U. S. NUCLEAR REGULATORY COMMISSION
OBSERVATION AUDIT REPORT OAR-99-05
OF THE YUCCA MOUNTAIN QUALITY ASSURANCE DIVISION
AUDIT M&O-ARP-99-12
OF THE
CIVILIAN RADIOACTIVE WASTE MANAGEMENT SYSTEM
MANAGEMENT AND OPERATING CONTRACTOR

9909160123 990909
PDR WASTE PDR
WM-11

Figure 1. Technical Document Hierarchy for LA Design

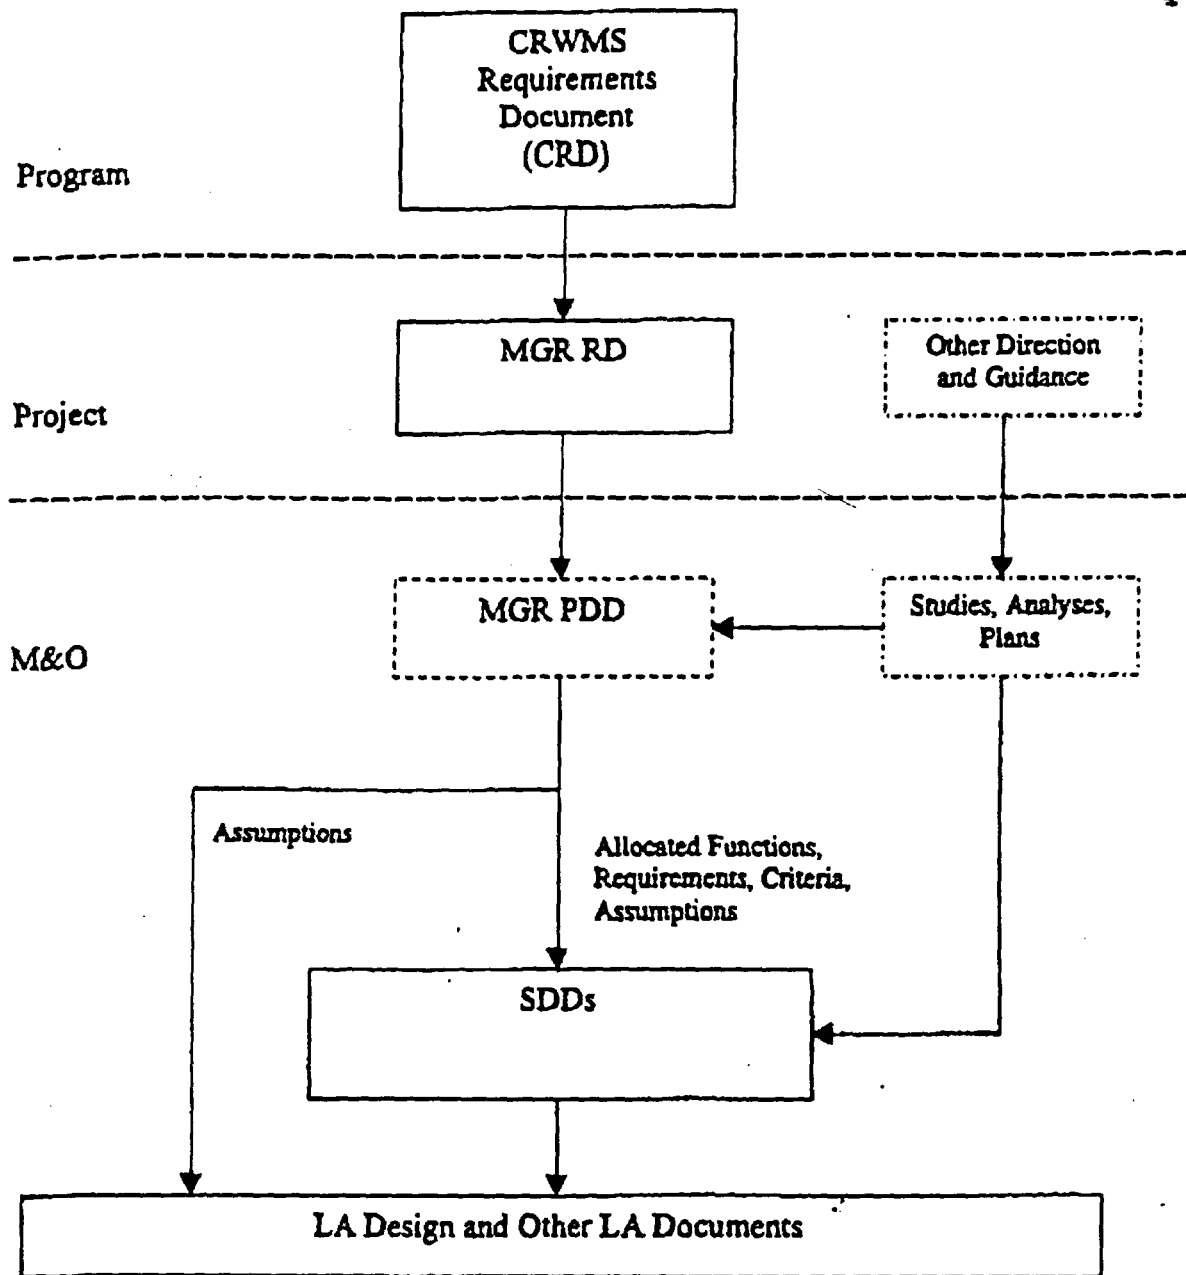
Document Hierarchy: In its effort to review the design control process, NRC staff have been raising the issue of DOE's (and M&O's) document hierarchy for quite some time. (See Issue Resolution Status Report of Repository Design Thermal-Mechanical Effects Key Technical Issue, section 5.1 and item 24 of its Appendix, September 1998.) As a follow up to that effort, the NRC technical observer requested the DOE audit team for the latest version of its document hierarchy that applies to its current activities. In response to this request, a copy of Figure 1- Technical Document Hierarchy for LA Design (a copy is attached to this report for ready reference) was provided to NRC via the NRC Site Representative's office. This proposed technical document hierarchy is expected to become effective when baseline document changes will be made to support a transition from VA to LA (i.e., when MGDS-RD, Rev.3 is baselined). The staff will continue to monitor DOE's progress in establishing a technical document hierarchy for its future design activities.
